Last month we restored a township corner near the head of Windy Cr. in Douglas County involving Federal and private lands as well as State Forests land. The corner is common to Township 31 and 32 South, Range 5 and 6 West, W.M., and is described in the attached corner report to the County Surveyor, and shown on the area sketch.

RESTORED CORNER FOR STATE OF OREGON--DEPARTMENT OF FORESTRY

Township corner common to Sections 31, 36, 1 and 6,
T31 and 32S, R5 and 6W, W.M., Douglas County, Oregon.

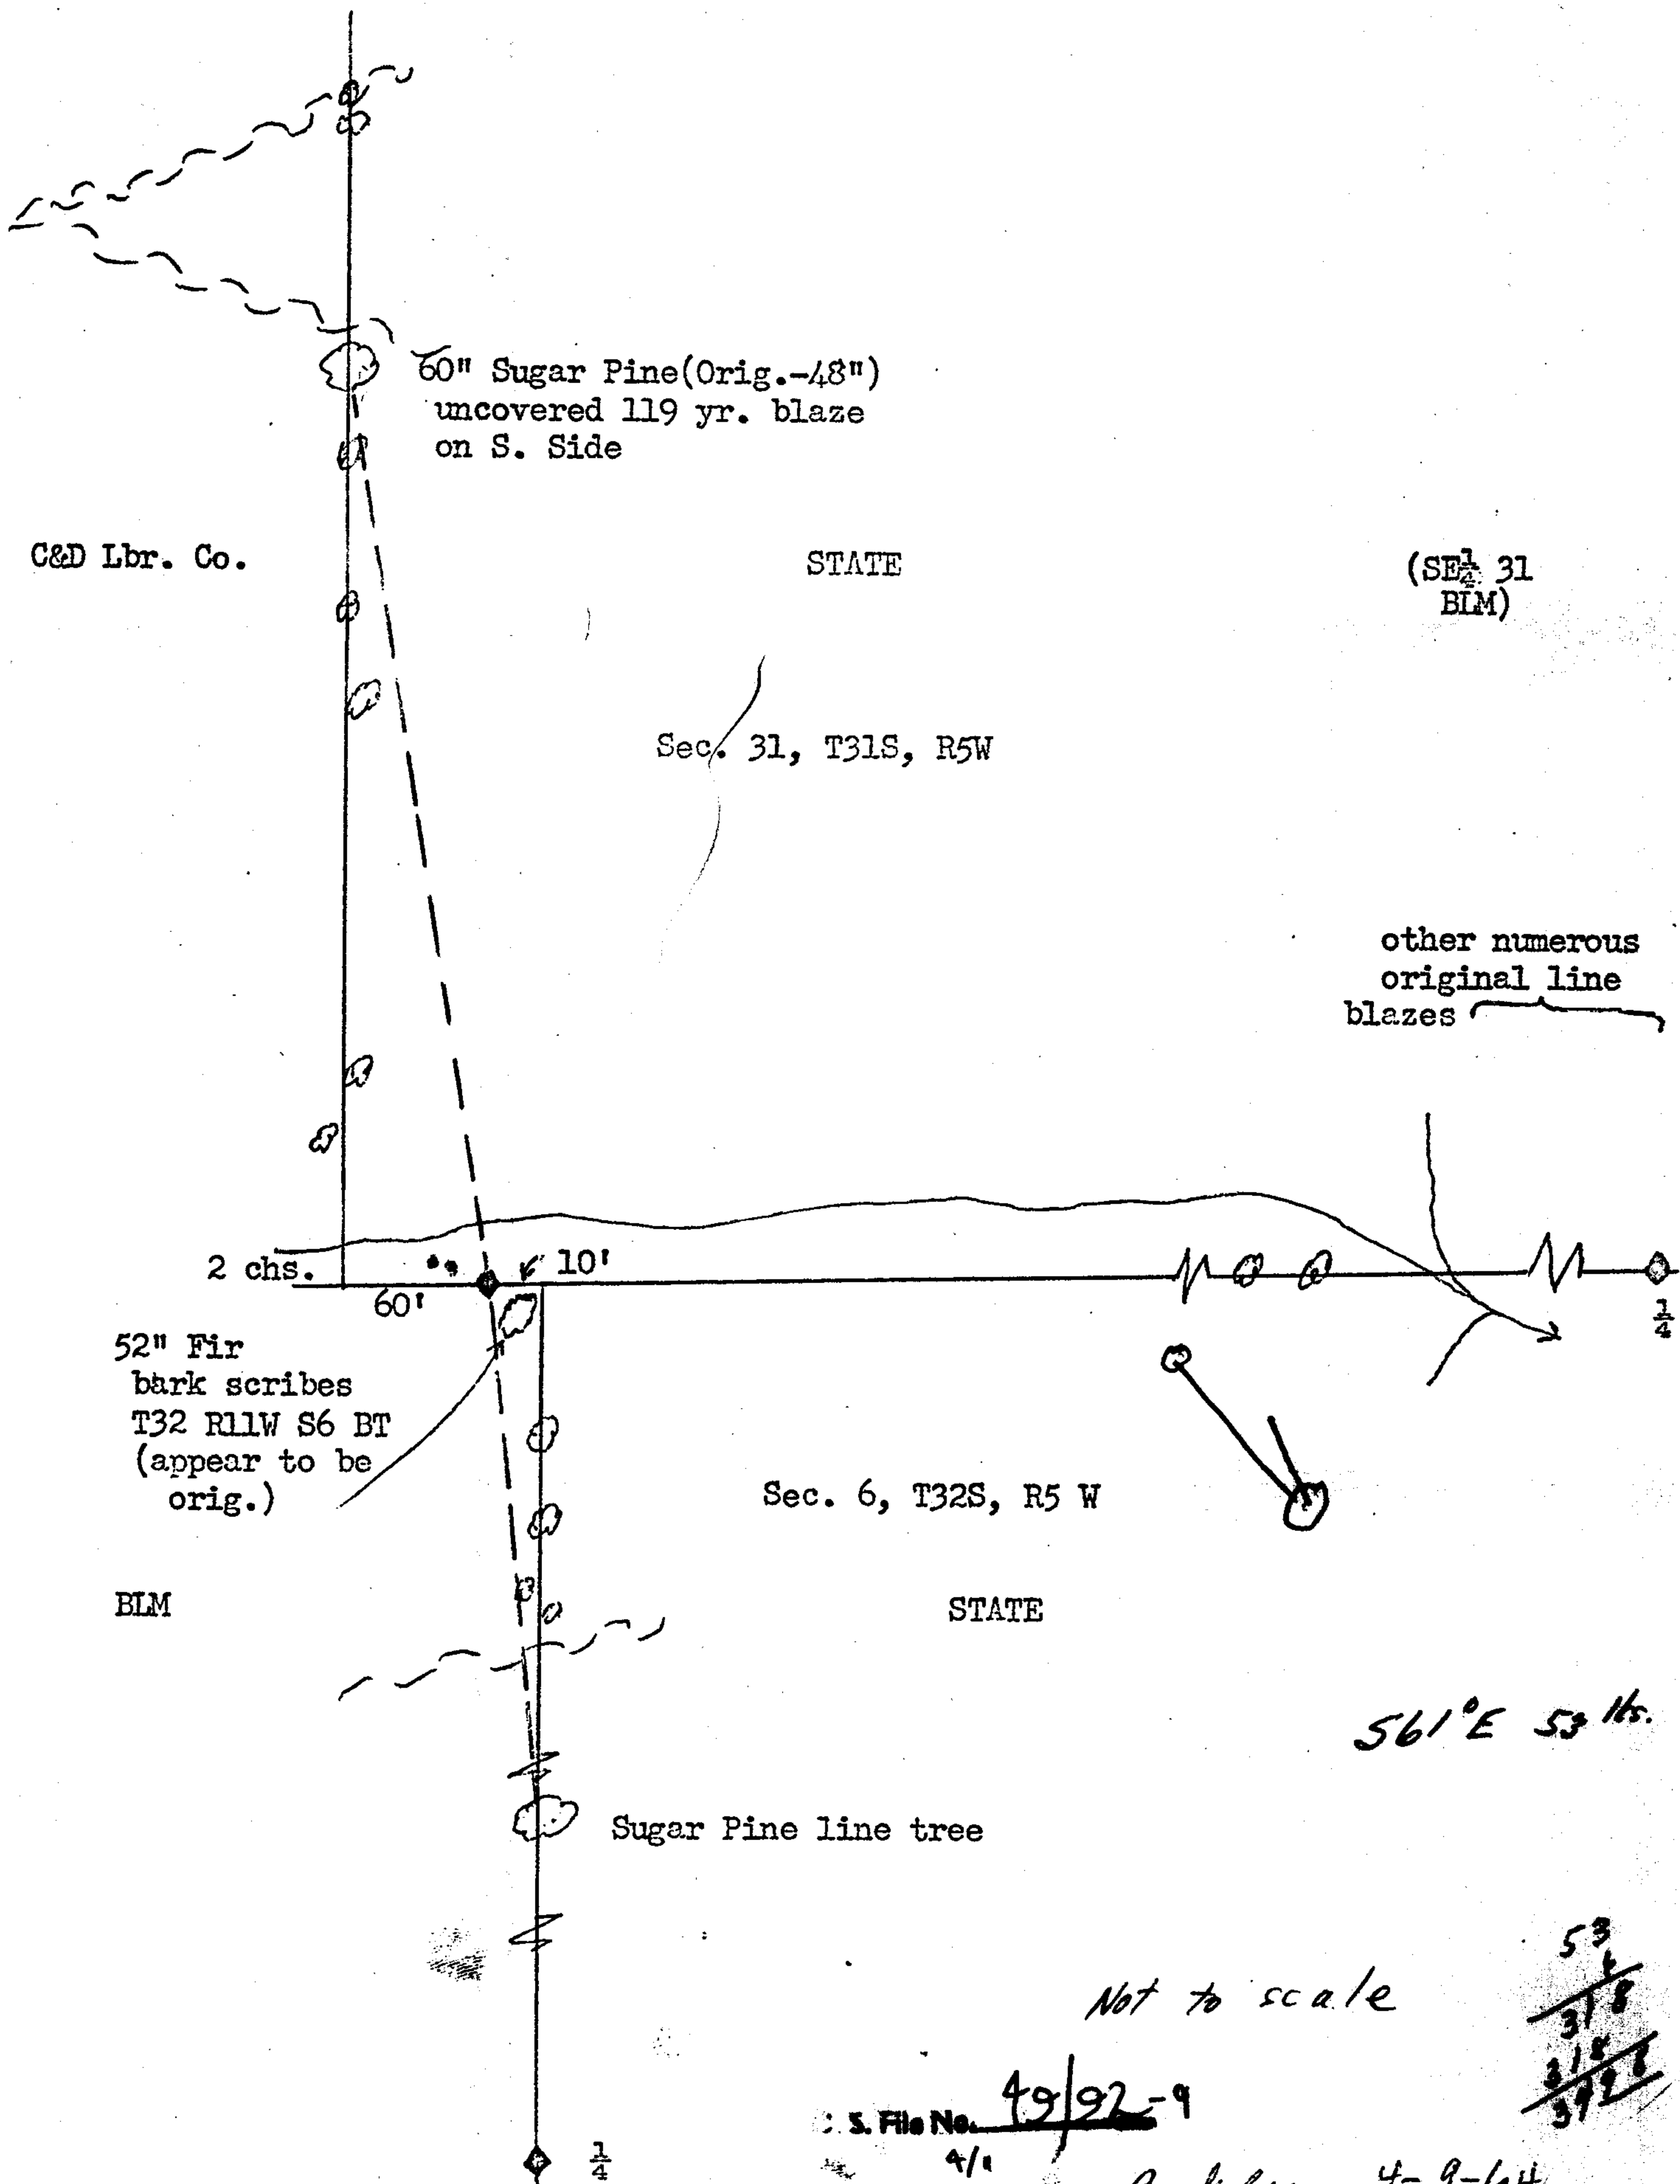
As indicated in the report there is a discrepancy in the junction of the range lines from North and South of the corner. At first glance it may seem that the corner should be at the end of the range line from the north, since the record (Lake & Hyde) called for it to be set at the end of that mile; and, actually it may legally belong there even now, although no bearing trees or remains are in evidence. When the range line was run from the south it supposedly tied into the existing corner which would make the first Lake & Hyde corner common to all four townships. Possibly they intended the 50' fir to witness a closing township corner, although the scribbling on it is complete and it does not include a CC. Since the half mile to the east is about 300 feet long, Lake and Hyde may have intended the BT at the closing point to witness a common township corner in an effort to offset some of the overage.

We restored the corner as set by the County as common to all four townships. This in affect would eliminate part of the blazed line north and south, and make the Sugar Pine line trees angle points.

No evidence of original record corner post or bearing trees found. County Survey No. 49/92 by Dep. County Surveyor George J. Wenderoth, April 11, 1959 states that a 52" Fir with scribes on North face was found, near which the Township corner was then set (3/4" iron pipe with 3 BTs - see below). The survey does not state what influence this tree had in reestablishing the corner.

Based on the scribes being very old, in the bark, and the style of handwriting being similar to other Lake & Hyde work in this township, I conclude that this tree is an original and that the record notes are in error.

Original line blazes were found on line east of the county corner. About 10 feet east, and south to the first ridge top numerous original blazes were found. Also approximately 60 ft. west, and north across an east and west creek to the top of the main ridge numerous original blazes were found, including some on a 60" Sugar Pine (Orig. 48" at 68.20 ch.) with 119 years of overgrowth. The creek flowing east at 2.00 chains north is in place.

The corner as set by the county seems as well correlated as practicable with the evidence close at hand; therefore we restored it as shown below.

The corner of Tps. 31 and 32 S., Rs. 5 and 6 W., as set by Lake and Hyde, in 1855, is a common corner as stated in your letter of April 9, 1964.

Your suggested treatment of making recovered line trees angle points is the procedure this office would follow.

However, the location of the corner point from the alleged original bearing tree would require further investigation. At present the corner point is not at record bearing and distance from this remaining tree and there does not appear to be any justification, from the information submitted, for placing the corner at any position other than at record bearing and distance from this tree. It is noted that this tree does not match the record for size, nor is the scribing facing in the proper direction. This is not uncommon and the scribing indicates that it is the SE. tree. If Wenderoth did not have any additional evidence of the other bearing trees and just placed his corner near this tree, accepting it as an original, then it is possible that we would make further field investigation. Your sketch failed to indicate the correlation of this corner, in bearings and distances, to found corners N., S., and E. This correlation would lend weight and should be considered in the acceptance of this remaining tree as the original.

If the field investigation along with the correlation to found corners and topo, indicates that this is the original tree, then it is possible that we would remonument the corner at record bearing and distance from this tree rather than at the position indicated by Wenderoth.

After studying all the material with reference to the Town Corner in question, I have come to the conclusion that the corner as set by Wenderoth is out of position, as it would seem that he ignored the line trees and set the corner by intersection rather than by double proportion. However, I do not believe that proportioning the corner in is the answer, as it would apparently make all the other evidence useless, completely destroying any possibility of validity of the 52" Fir.

I believe that I would make the same decision as Mr. Zirpel, and put the corner in, using the 52" Fir as control, regardless of the position of the scribing, as we have found many cases where this condition exists. This would move the corner approximately 25 feet west and 6 feet north of Wenderoth's corner, and I would connect the lines to the Sugar Pine Line trees and the recoverable corners to the east and west. This will not materially effect the topography, nor would it disclose any serious trespass, in my mind.

Since you mention your wish to witness the Sugar Pine trees on your next trip down, I would appreciate having you set the Town Corner as outlined and tie in Wenderoth's corner, leaving it in position. It is the policy of this office to leave all corners as set on private surveys where we differ with their position. Mr. Wenderoth is a deputy true, but this corner was set in the course of a private survey and was not as a result of an official department survey.

During this time I will witness the two Sugar Pine line trees and set a $1\frac{1}{2}$ " x 36" galvanized iron pipe and bronze cap for the township corner as you and Mr. Zirpel recommend. I am in accord with using the 52" Fir as the southeast BT, unless we find additional evidence.
